CITY OF FORT LAUDERDALE

CASE COMMENT REPORT

CASE NO. UDP-S24067

| PROJECT NAME: | Cypress Creek Station - Target |

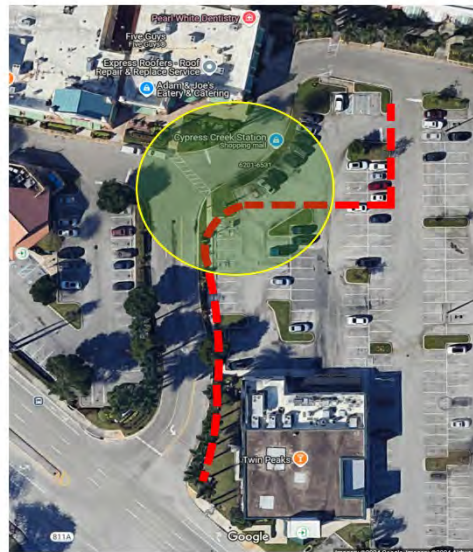
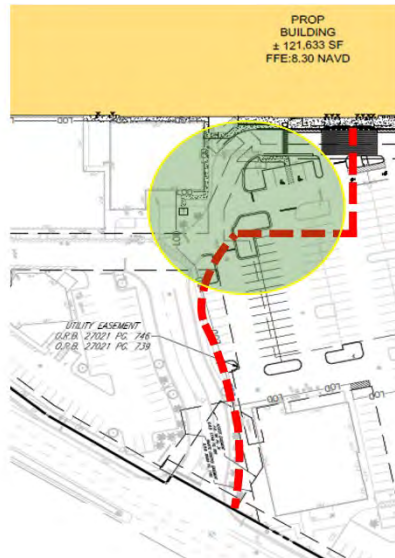
- a. Enhanced pedestrian connection. Provide 10-foot wide sidewalks into site from public sidewalk (red dotted lines) at the main entrance and secondary entrance near future pad. In addition, examine the creation of plaza space that establishes a sense of place near building entrances that connect to the sidewalk (circled area) with plaza features; e.g. seating, trellis, illuminated art, etc.

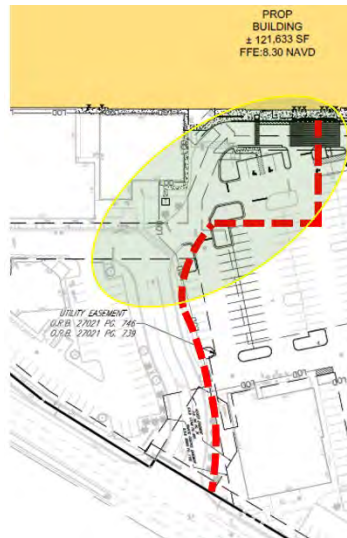
- a. Provide an overall illustrative site plan that clearly depicts the property with the site boundaries, setbacks, and proposed changes. Remove any unnecessary dimensions. See example image below.

- c. Clearly label on site plan the location of enclosure(s), dumpster(s), recycling area(s), containers, etc. as applicable relating to Solid Waste / Recycling. Indicate on plans where users' accessibility is accommodated for all container areas.
d. Redesign the proposed vehicular area, indicated by circle below, as it is unsafe, contains numerous movements, creates conflict with pedestrian crossings.
